Absolute Qualitywear Ltd.

18 December 2022

Observations

Significant connection gap and bolt missing

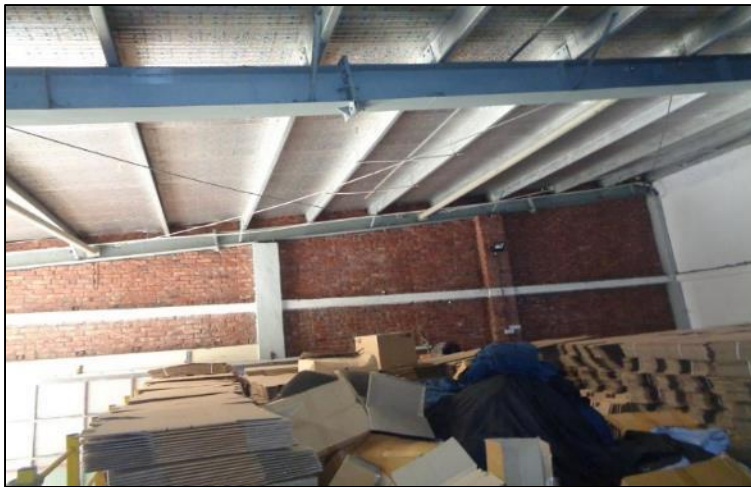
Bolt missing at several locations

Significant connection gap

Bolt missing and significant connection gap was observed at several locations.

Factory engineered is required to

- Install the missing bolt,
- Take proper measure to fill up connection gap.

Inactive & loose cable bracing

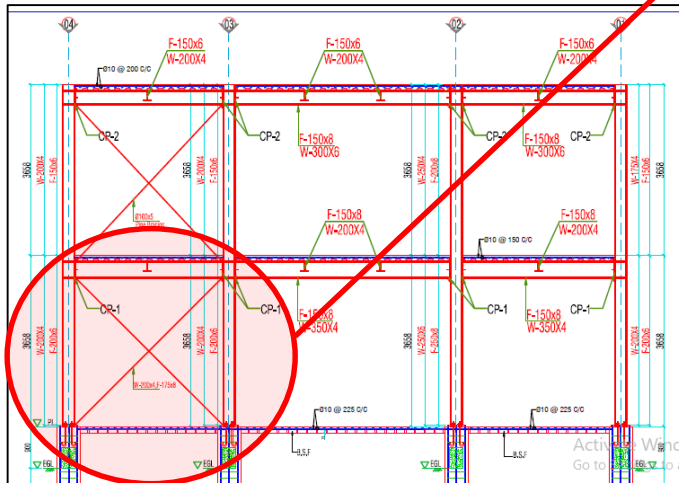
Loose cable bracing at several location

Inactive cable bracing (inserted in partition brick wall)

Loose cable bracing & inactive cable bracing were observed at several locations. The factory is required to tighten the loose bracing & free the load path of the inactive bracing properly.
